# CTLE for the C2M reference receiver

(supporting comment 127)

Adee Ran, Cisco

April 2021

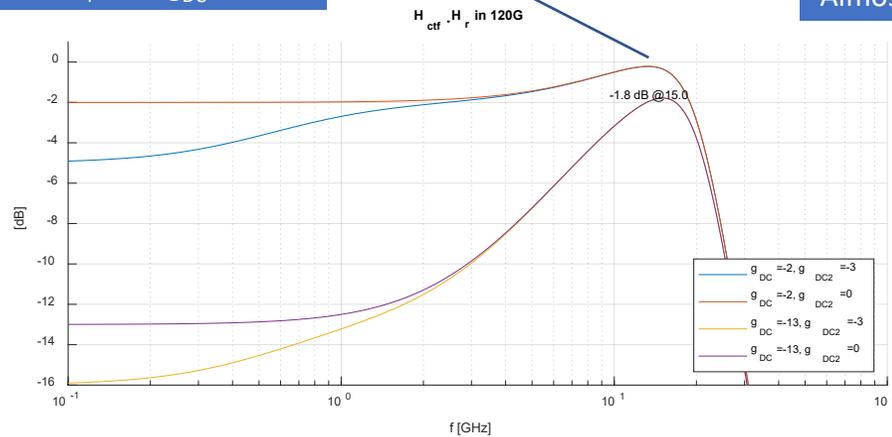
Up to 0 dB after H<sub>r</sub> with  $g_{DC} = 2$

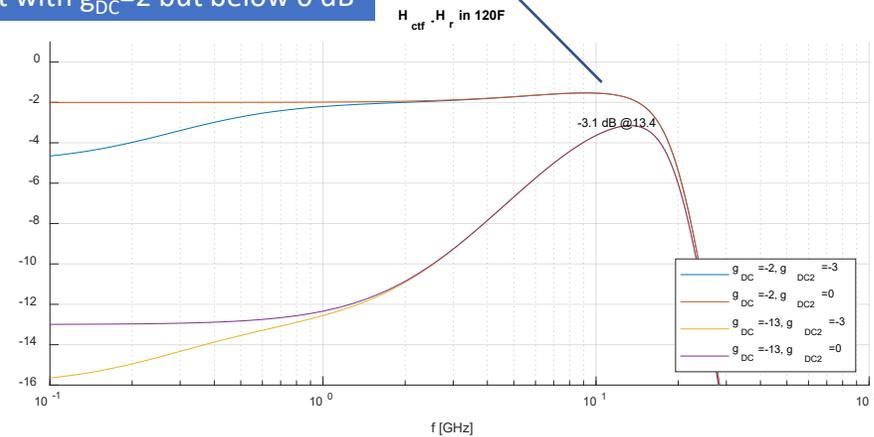
Almost flat with  $g_{DC} = 2$  but below 0 dB

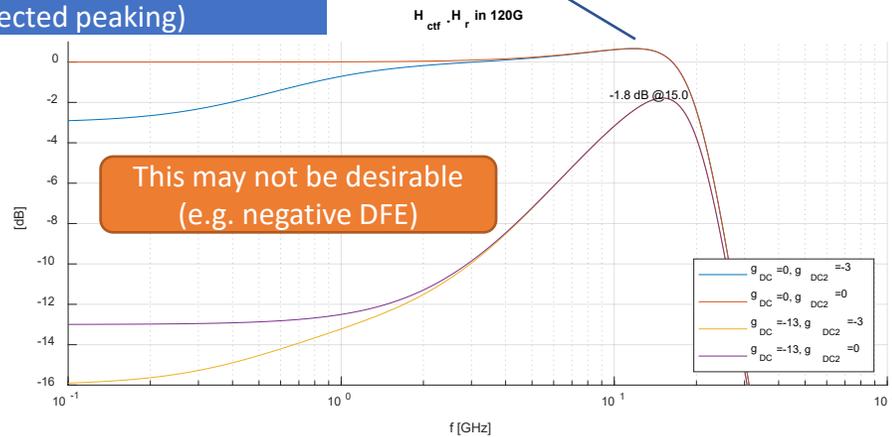
Goes above 0 dB even after  $H_r$   
(unexpected peaking)

This may not be desirable  
(e.g. negative DFE)

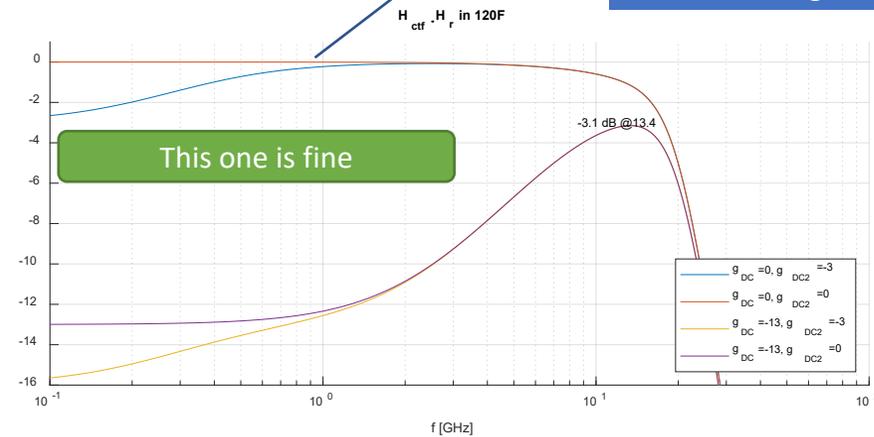
Flat, starting at 0 dB

This one is fine

# Module output (TP4 far-end)

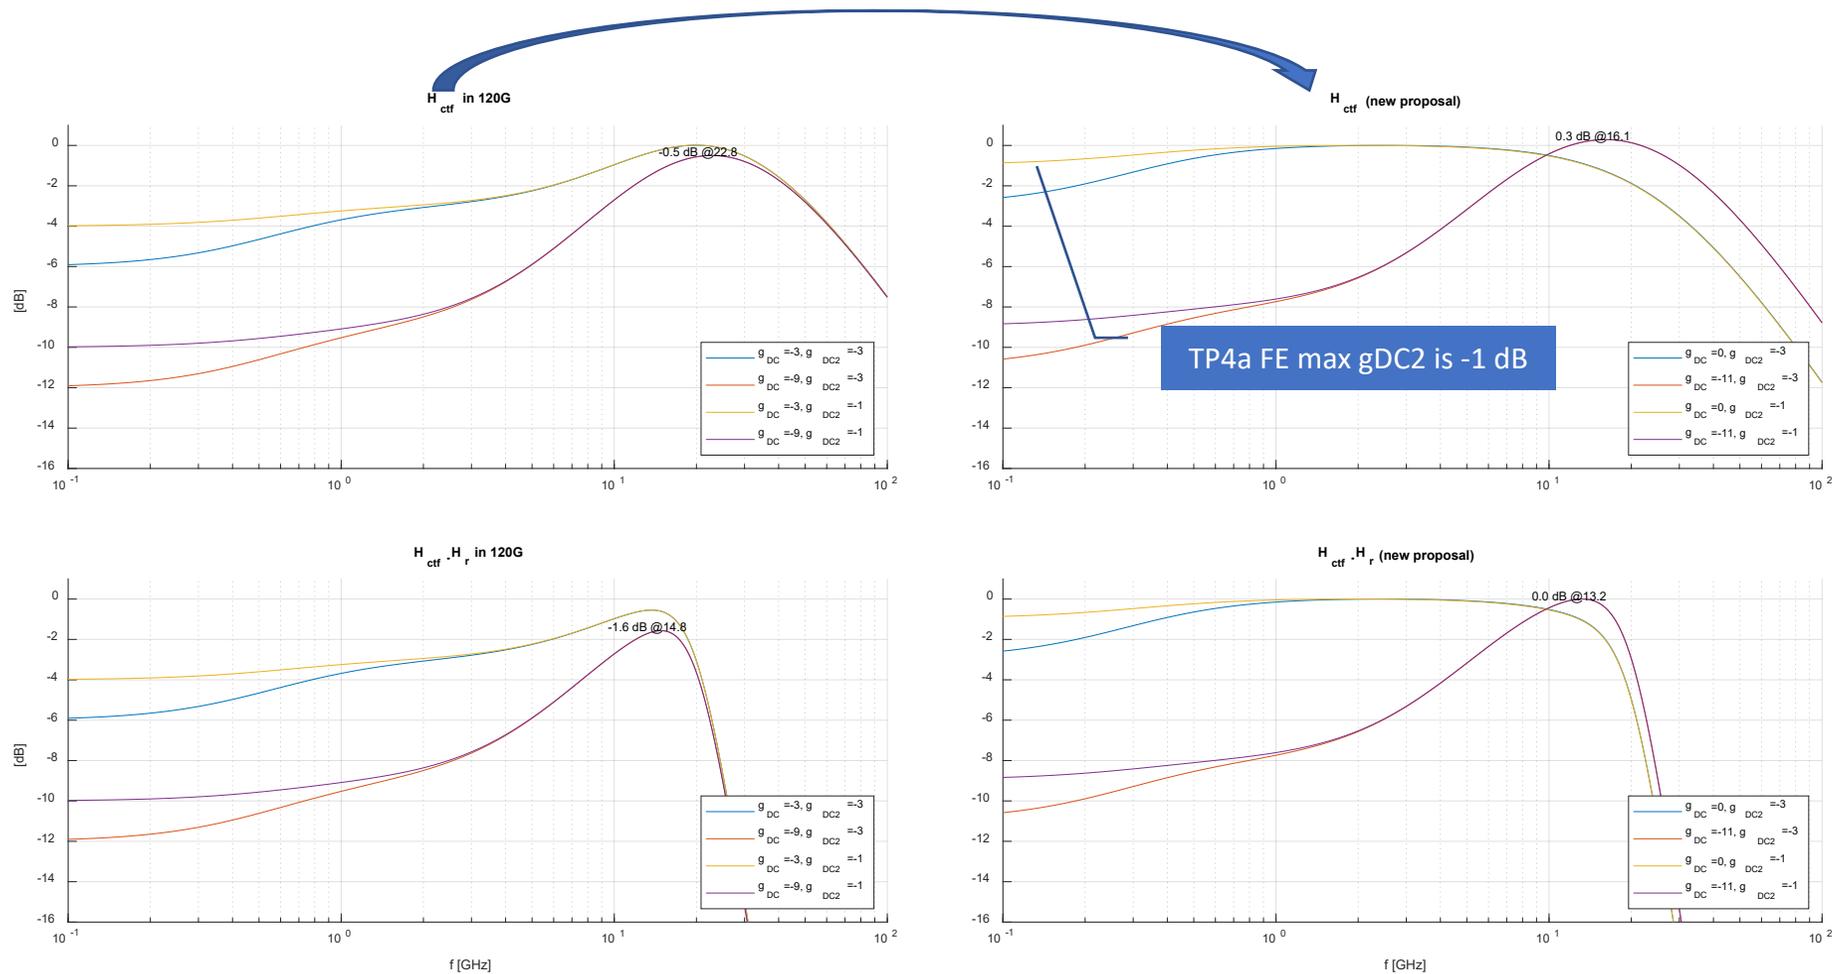
It may not be necessary to allow  $g_{DC}=0$  in this case
